Addendum No. 02

Issued: 9/13/2024

Project Name: Jordan Learning Center
Project No.: 2024528.00
Bid Package: 1

C2 ELEVATION
 SF201 SCALE: 1/8" = 1'-0"

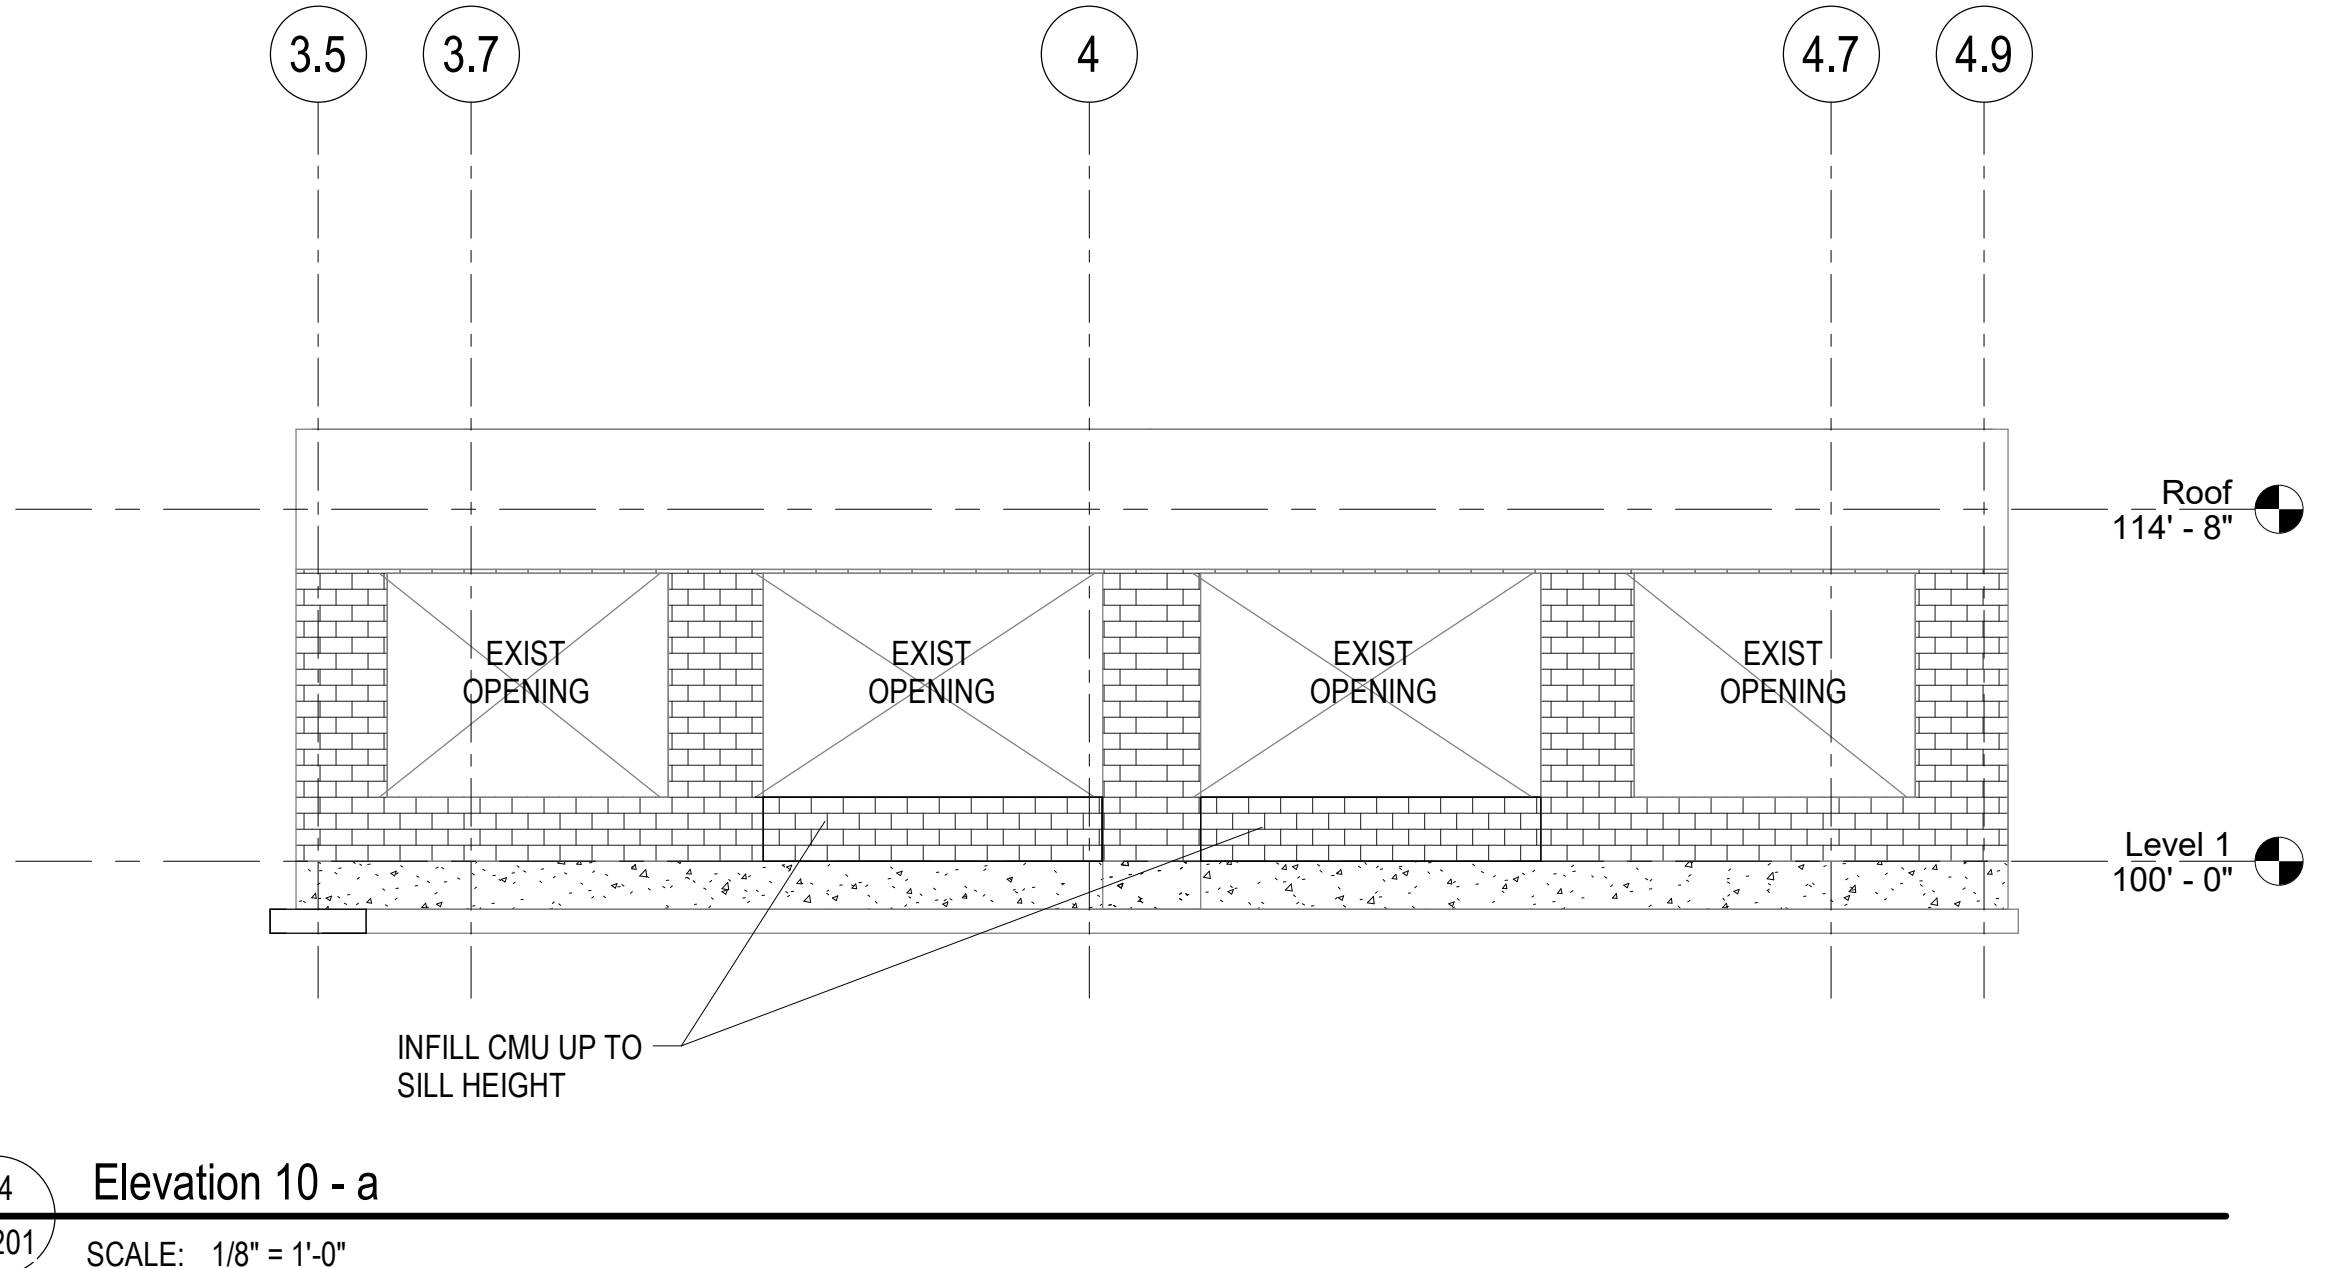
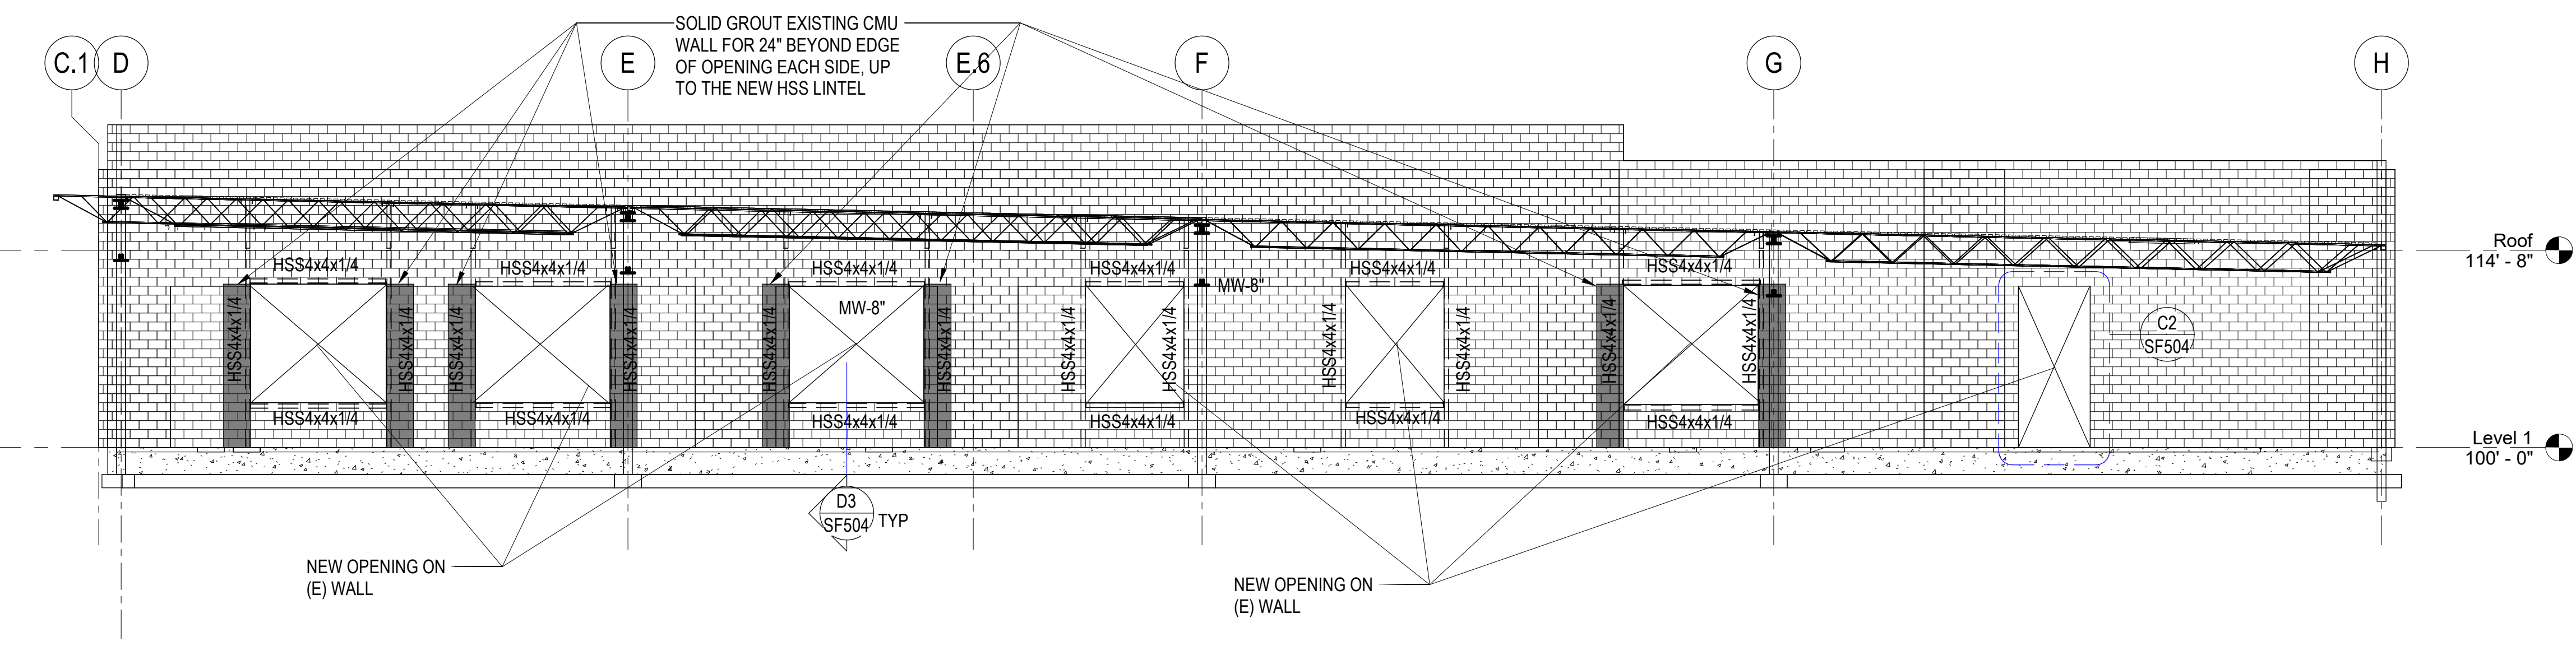
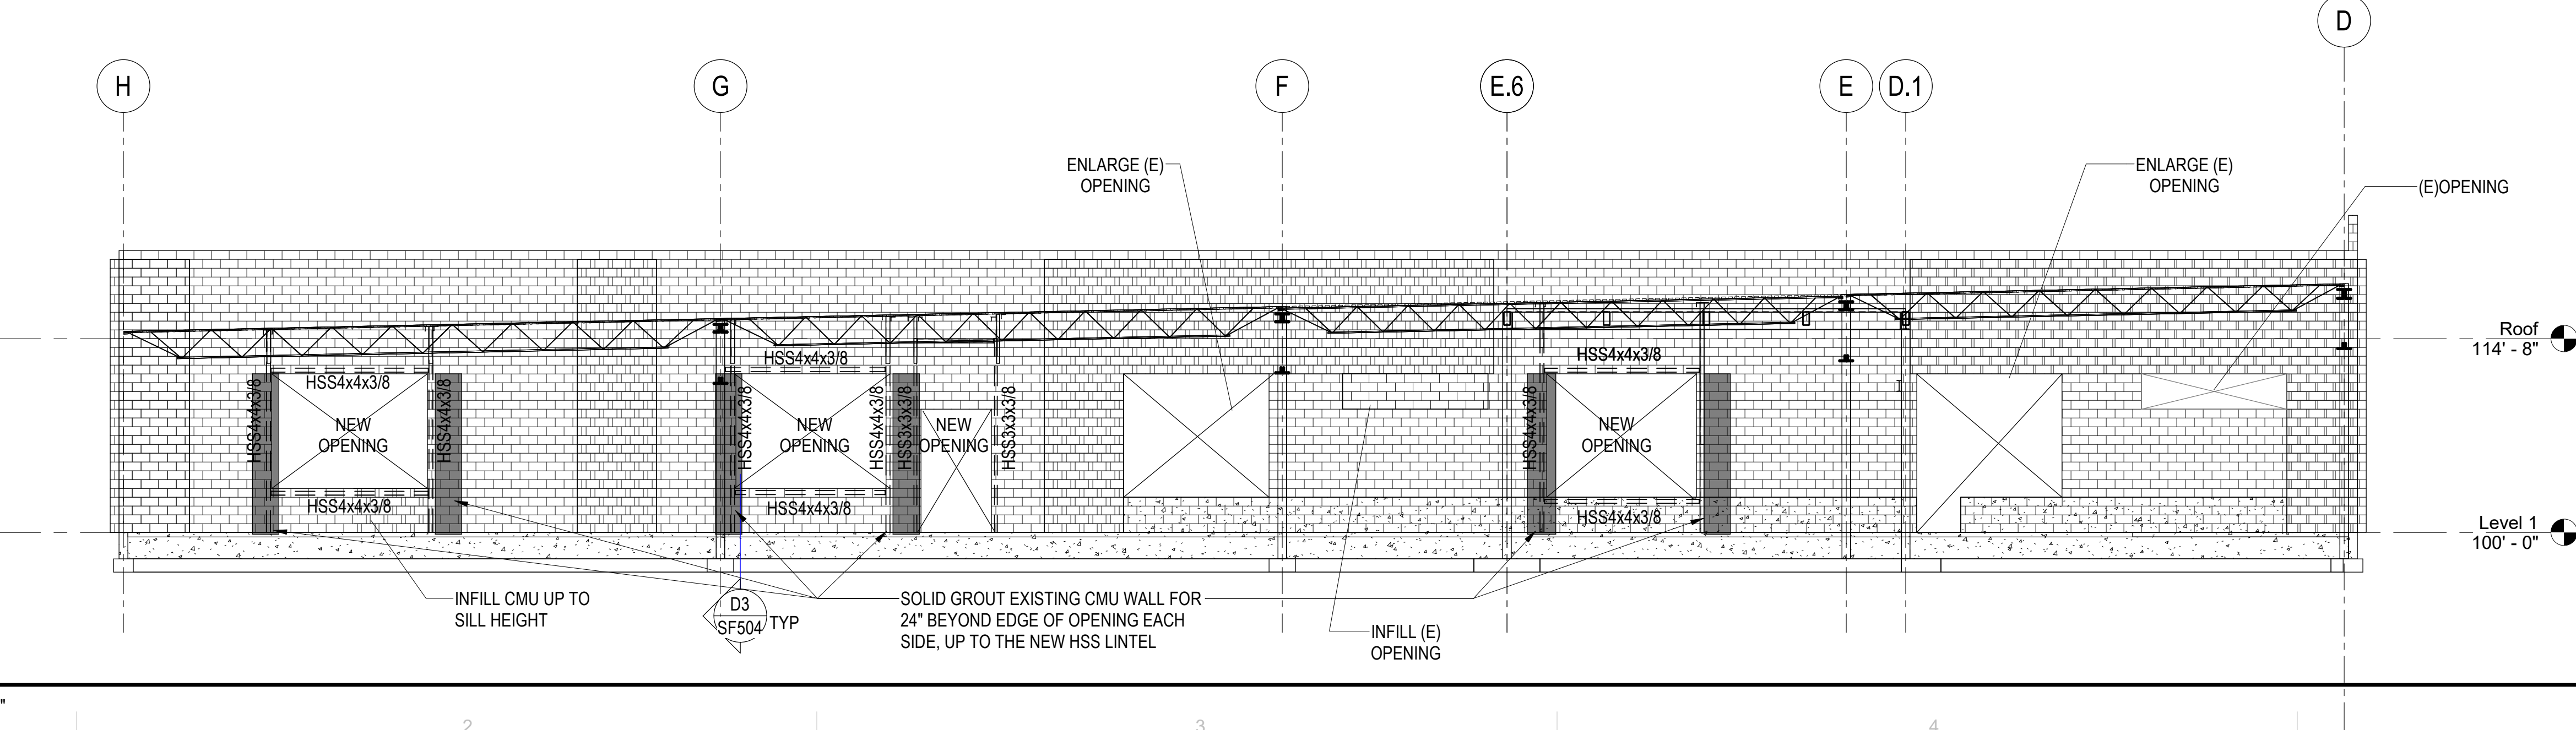
- Added the additional setback tube columns and HSS lateral support per SF101A and B.

SHEET NUMBER
SF503

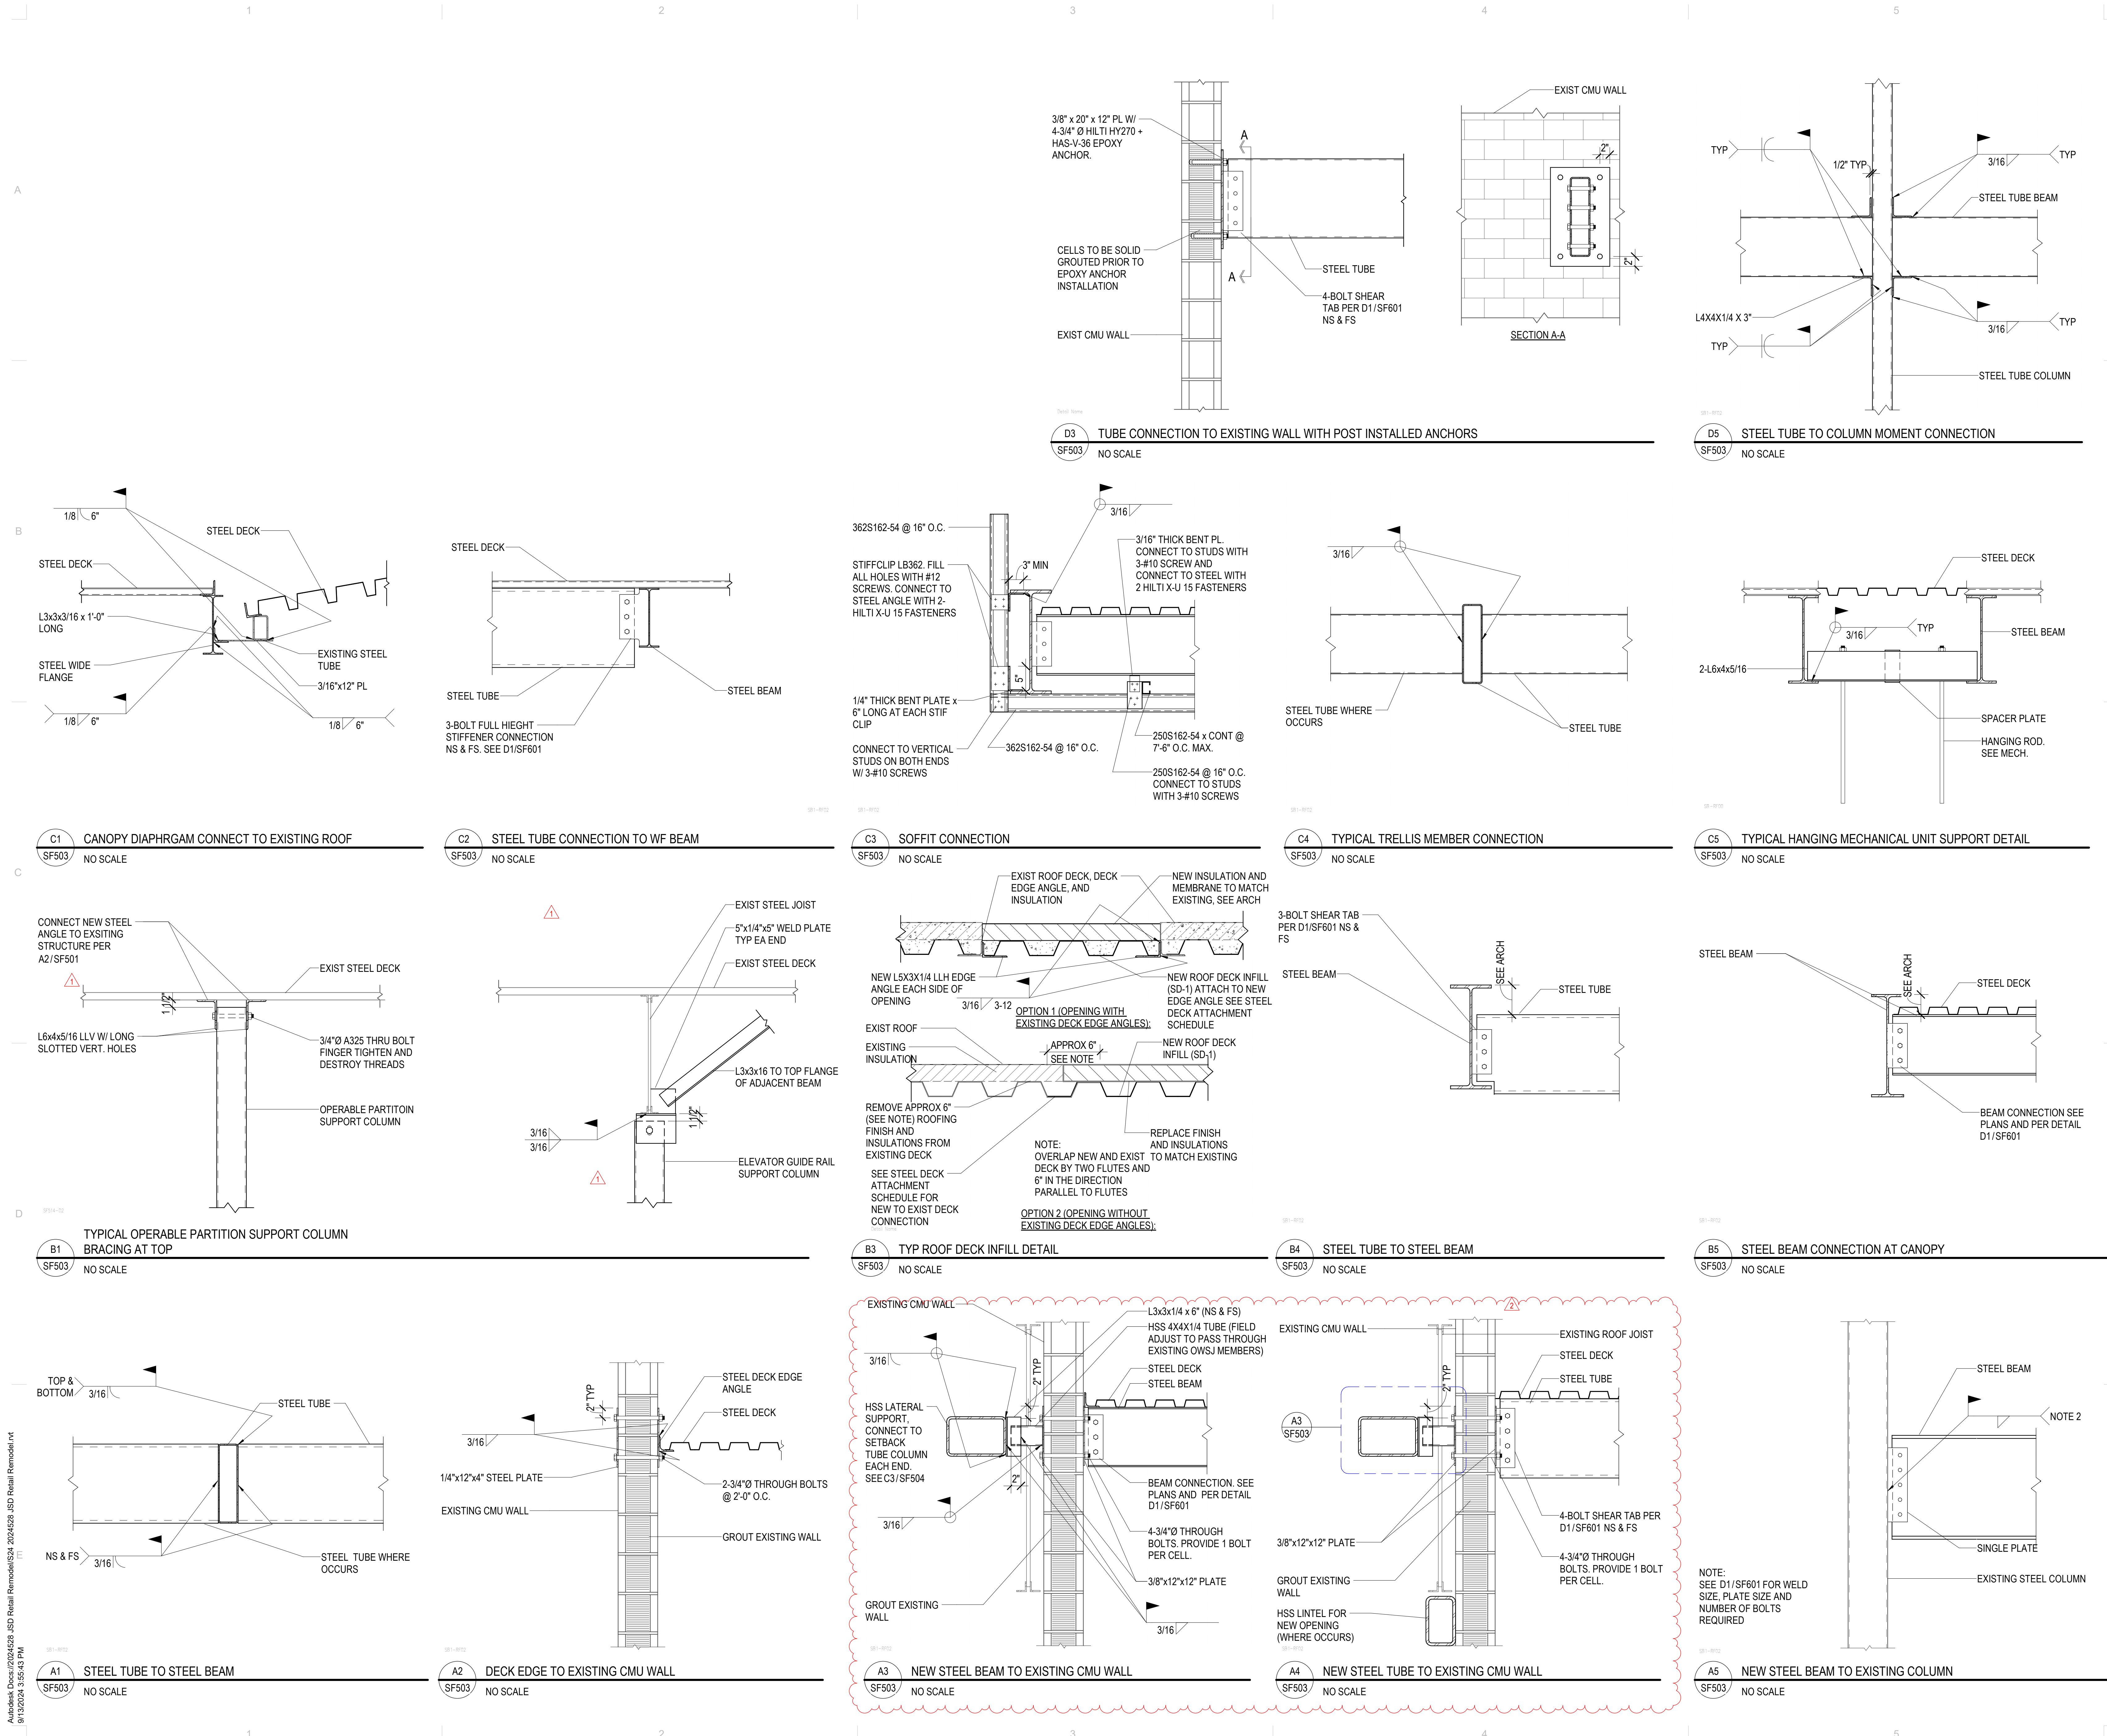
- Updated detail A3 and A4 to reflect the HSS lateral support on the opposite side of CMU wall to the canopy framing with through bolt embed connections.
